## Asset 9: Norgrove Park wetland

## Asset 10: Emu Bank wetland

## Asset 11: David Street Pond

## Asset 12: Dickson Pond

**Figure 1: Flows bypassing the pond after rain event on 16 November 2014**

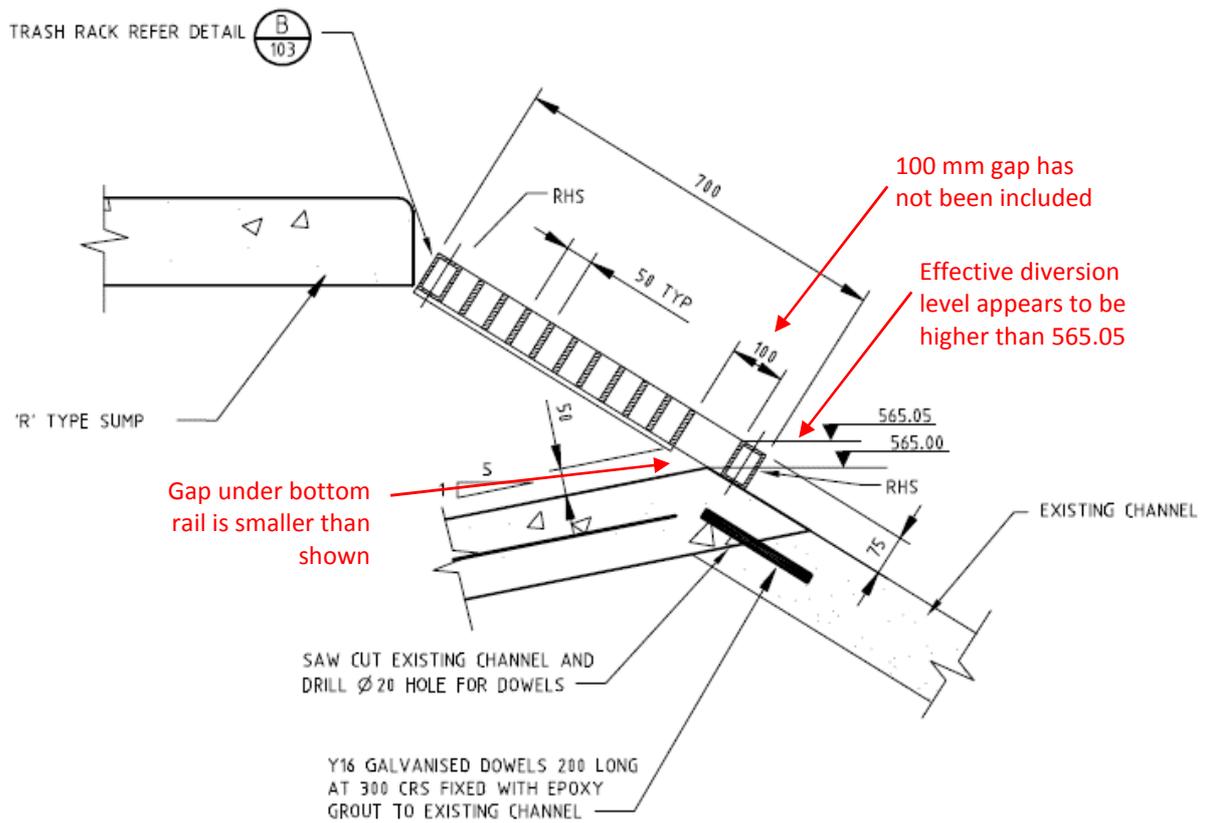
In terms of the pond's performance as a water quality treatment and flow attenuation system, this has never been measured, however our site observations indicate that there are some significant limitations. The key performance issue at David Street is the performance of the diversion structure from the stormwater channel. The diversion structure has the following key limitations:

- There is a very small level difference between the diversion weir and the overflow weir, so it bypasses very easily.

- The trash rack blocks easily. The design of the trash rack is such that at the base of the rack there is a very small opening between the lowest rail and the concrete structure underneath, which is the first part to block.

Figure 1 shows the condition of the diversion structure when we visited the site on 16 November 2014. Almost all inflows were bypassing the wetland due to significant blockage of the trash rack. We cleaned the trash rack on 16 November and observed that after this, most of the inflows entered the wetland. However we returned to the site during the next rain event on 24 November to find that even with minimal blockage of the trash rack, significant flows were still bypassing the wetland due to a very small level difference between the diversion level and the overflow weir. Design drawings indicate a 100 mm level difference, however it appears to have been constructed with effectively no level difference. The detailed issues are highlighted in Figure 2.

The Preliminary Assessment Report for David Street pond indicated that the design flow intended to be diverted into the system was 300 L/s prior to any overflow of the weir in the main channel (SCCG 2001), however our observations indicate that the actual diversion flowrate is well below this.

1. Re-design the diversion to function as originally intended
2. Increase the notional detention time by re-designing the riser outlet
